**February 7, 2017**  
**BOARD OF COUNTY COMMISSIONERS**  
**ORANGE COUNTY, FLORIDA**  
**Y17-730-MM / ADDENDUM #1**  
**ORANGE COUNTY CONVENTION CENTER NORTH SOUTH BUILDING EXTERIOR**  
**LIGHTING ENHANCEMENTS**  
**Bid Opening Date: February 14, 2017**

- A. The Bid Opening Date remains February 14, 2017 at 2:00 P.M.
- B. The following are responses to the Orange County Electrical Plan Review comments received on December 27, 2016:

ADD/REV A/R#-	ASI/RFI	DR BCS	CK BJL
DATE	01/20/2017	JOB NO #2016299.00	
SCALE	N/A	<b>E1</b>	
REFER TO SHEET NO	E9.003

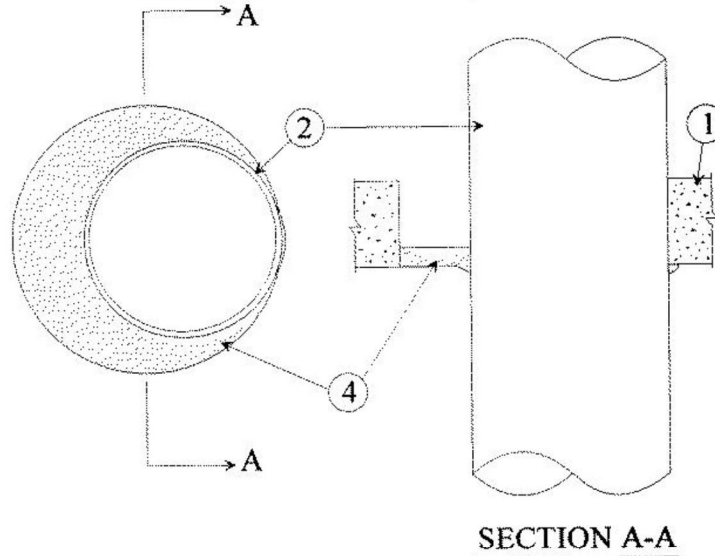
3. Comment: PROVIDE AN EXACT COPY OF DESIGNS FROM THE UL FIRE RESISTANCE DIRECTORY WITH SYSTEM NUMBERS FOR ALL ELECTRICAL PENETRATIONS OF FIRE RATED WALLS, FLOORS AND CEILING ASSEMBLIES. (F.B.C. CHAPTER 7, SECTION 714) - \*\*\*\* ONLY COMPLETE AND EXACT COPIES FROM THE UL FIRE RESISTANCE DIRECTORY ARE ACCEPTED BY THIS DEPARTMENT. \*\*\*\* CUT SHEETS FROM A MANUFACTURER ARE NOT ACCEPTABLE. \*\*\*\* The details sheet E9.003 do not meet the criteria of this AHJ. If you wish to use the details indicated on sheet E9.003 please provide complete and exact copies from UL.

**Response: UL Directory detail sketches (E1 through E9) have been provided and include the following:**

- **Sketch – E1 – System No. C-AJ-1184**
- **Sketch – E2 – System No. C-AJ-2630**
- **Sketch – E3 – System No. C-AJ-5091**
- **Sketch – E4A – System No. C-AJ-5320**
- **Sketch – E4B – System No. C-AJ-5320**
- **Sketch – E5A – System No. C-AJ-2007**
- **Sketch – E5B – System No. C-AJ-2007**
- **Sketch – E6A – System No. C-AJ-1361**
- **Sketch – E6B – System No. C-AJ-1361**
- **Sketch – E7 – System No. C-AJ-2236**
- **Sketch – E8 – System No. C-AJ-5029**
- **Sketch – E9 – System No. C-AJ-5225**
